**Asset Protection Zone Plan – Australian Golf Ski Club, Perisher Valley**

Australian Golf Ski Club - Perisher Valley

APZ Plan

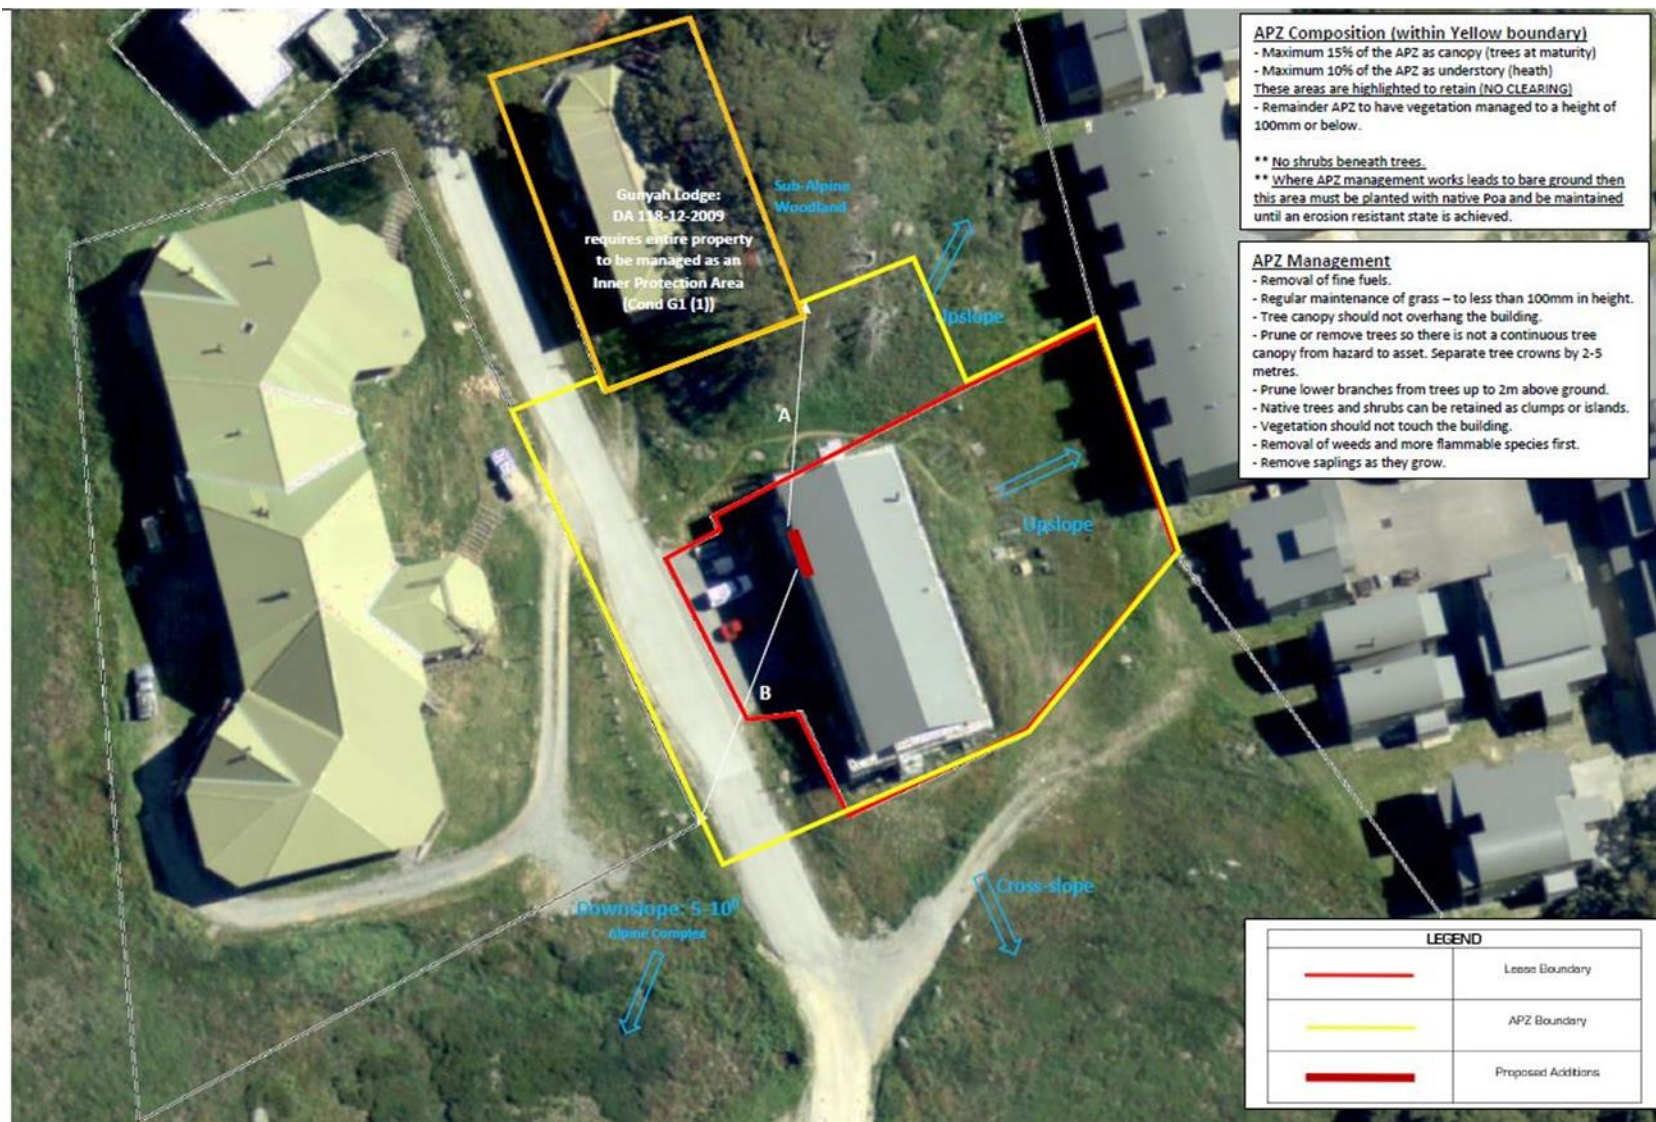
The distance between the proposed development and the Sub-Alpine Woodland vegetation to the north is 24m.

The distance between the proposed development and the Alpine Complex vegetation is 30m. The Alpine Complex vegetation is located downslope of the subject site at 5-10 degrees downslope.

These distances are shown in the endorsed APZ plan provided in Attachment A.

Accordingly, the construction standard condition is sought to be revised to BAL-19.
